**DATE:** October 25, 2019

**CASE NO.:** AME2018 0004

**PROPOSAL:** Proposed Rezoning of Downtown Juneau Alternative Development Overlay District (ADOD) Area

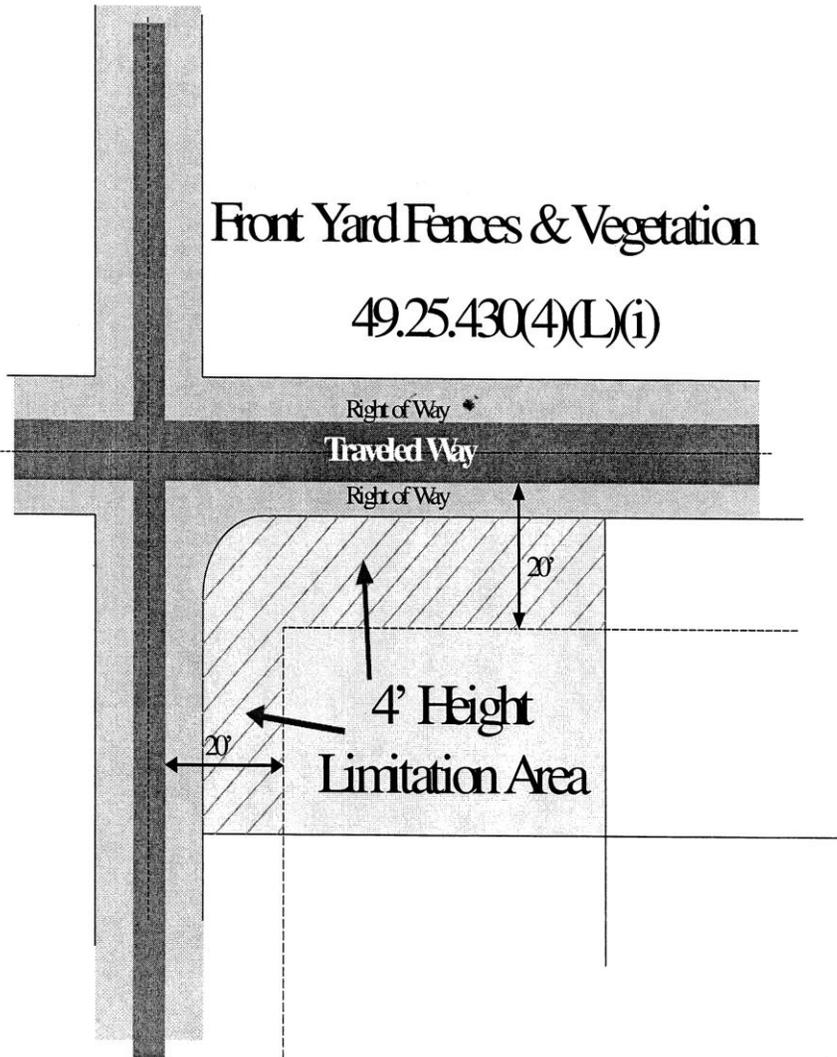
AL- ADOD should override this? If we're fine with buildings, arguably more visually obtrusive than fences, to be closer to a ROW, then we might consider allowing fences to do the same. However, if we want to reduce fence height because of a *desired streetscape*, e.g. one that has a more friendly than gated, then fences could stay low.

LC – I can go either way. We should ensure that the 20' setback sum does not apply to fences.

IG- I hate this corner lot part, because 3' is still hard to see over if you are in a little car. But, these areas have sidewalks so I guess it works out, it is not like it comes right up to the edge of the road.
